THE CITY OF KEY WEST

ADDENDUM NO. 1

Truman Waterfront Park Phase 1B- Building 1287 & Field

ITB 19-026

Sheet Number:
S-1.0
Date: AUGUST 12, 2019

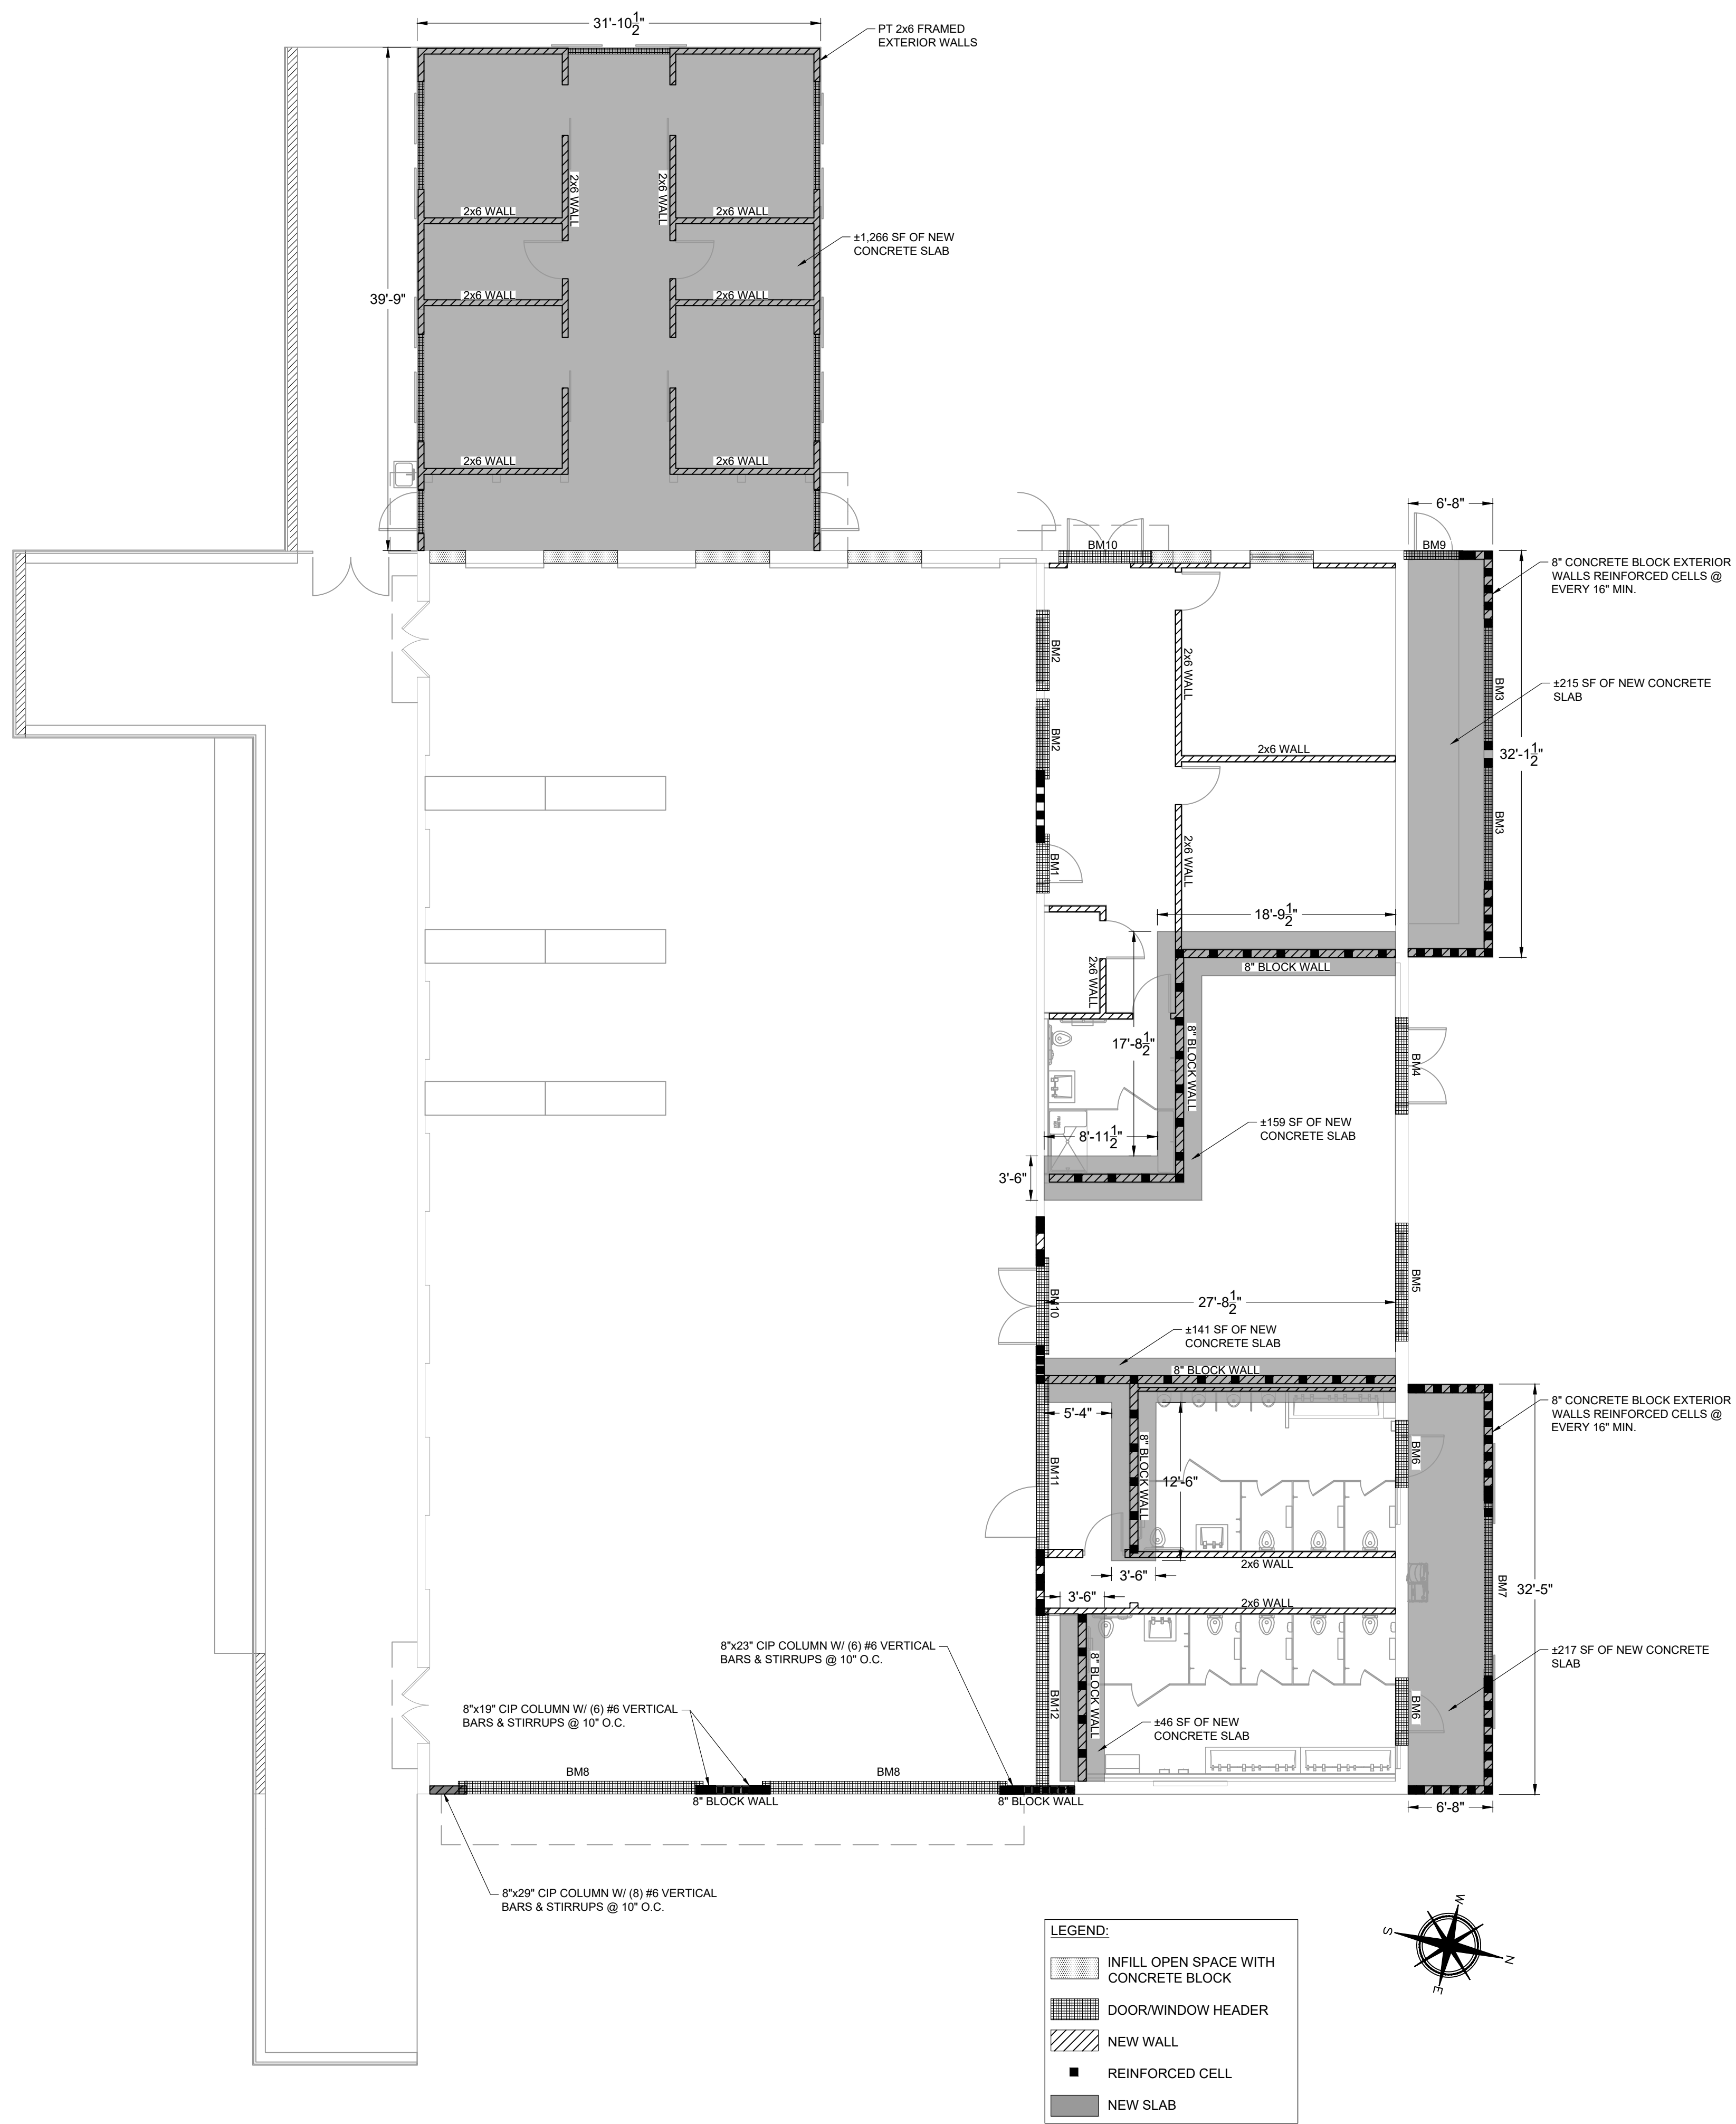
- 44. Plan sheet S1.0 refers to a detail 5 on sheet S4.0, that isn't included on S-4.0, please provide.**

K2M Response: Sheet has been revised. It should have been referencing detail 3 on sheet S-4.2. See sheets attached to this Addendum

Sheet Number:
S-4.0

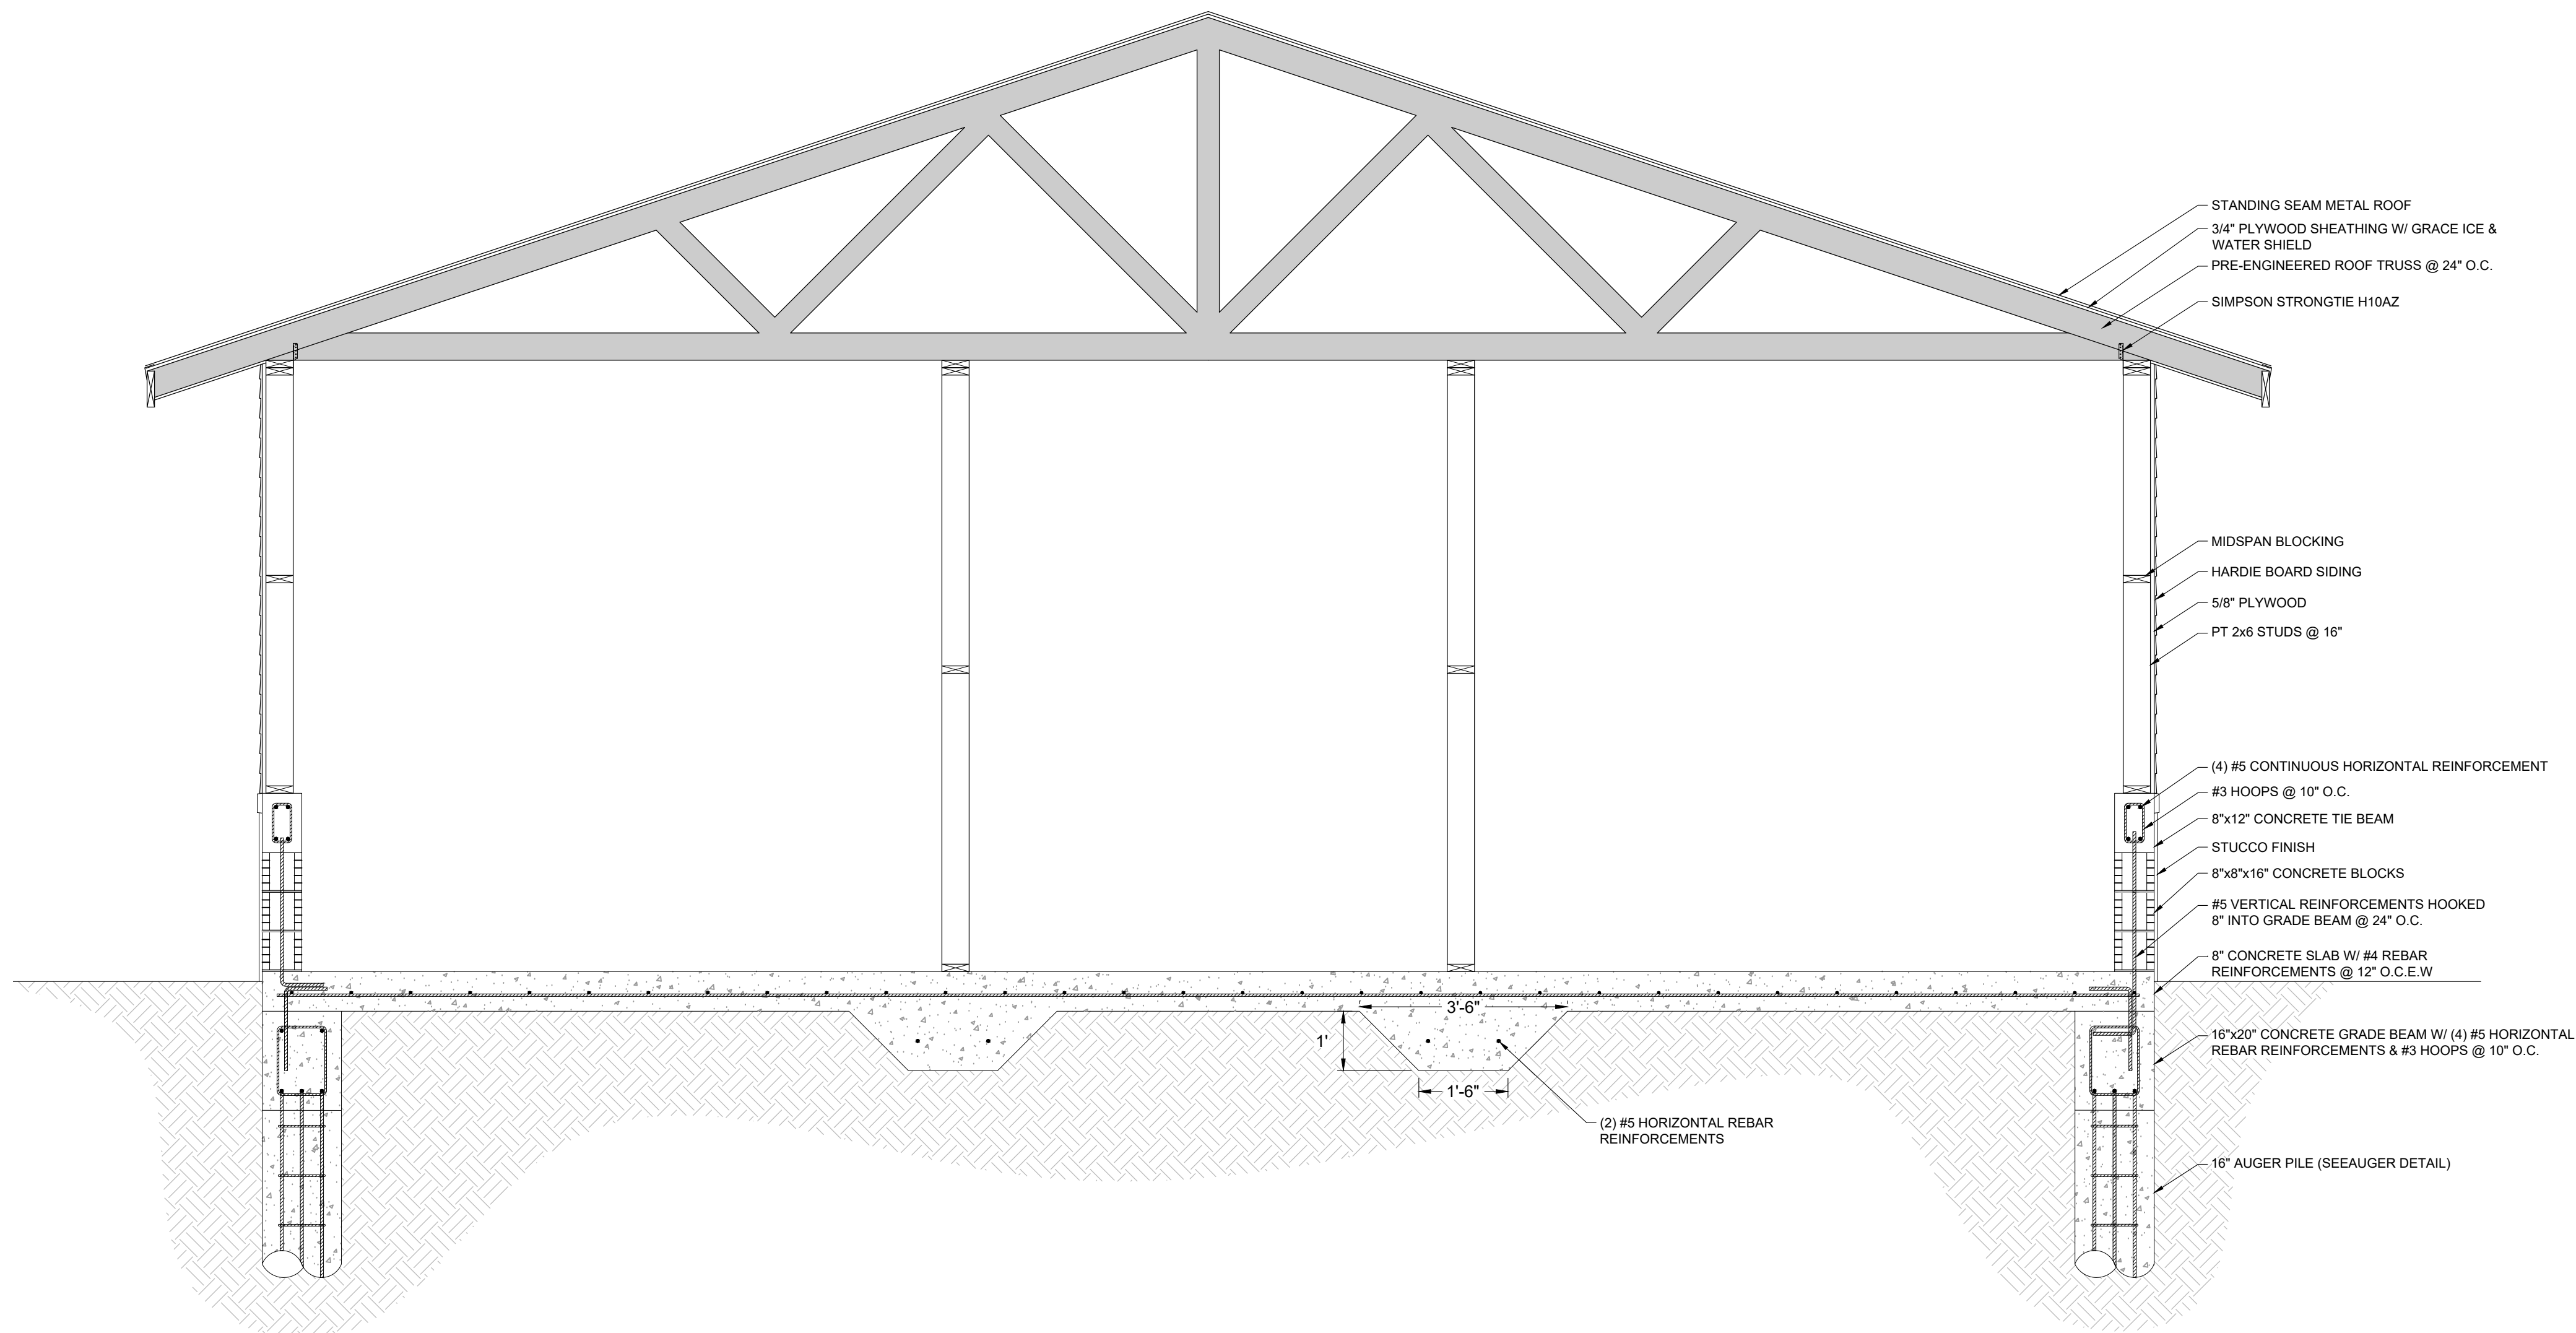
9. **Sheet A2.1.0 calls for a type D wall to the exterior perimeter walls which is a 2x6 PT wood stud, from the finish floor to the underside of structure with a 3/4" plywood on the inside and outside face. Sheet S-4.0 shows a short 8" wide CMU with a tie beam with a 2x6 PT wood stud on top of the tie beam with 5/8" plywood on the exterior face only. Please clarify which detail we are to follow? Also, if detail S-4.0 is correct, how high is the stem wall have to be?**

K2M Response: Use detail on sheet S-4.0 and stem wall should be 3'-0" ([3]CMU + 12" tie beam) See sheets attached to this Addendum

9 SPREAD FOOTER DETAIL
S-4.2 SCALE: N.T.S.

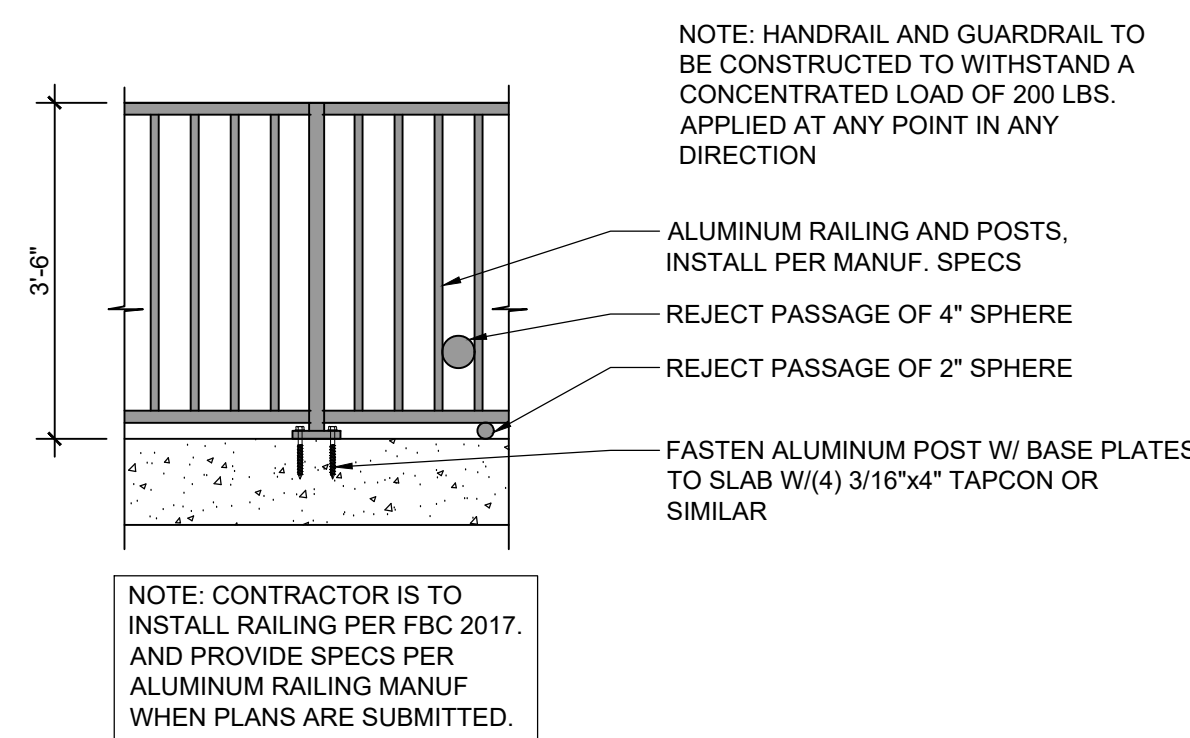
8. **P1.1.1 show the sewer drains at different location throughout the building. This means the slab will have to be cut to accommodate the pipes. Should the contractor follow rebar dowel details shown on 9 on S-4.2 to epoxy #4 rebar at 12" OC and concrete patch the concrete floor?**

K2M Response: Created New detail 12 on sheet S-4.2
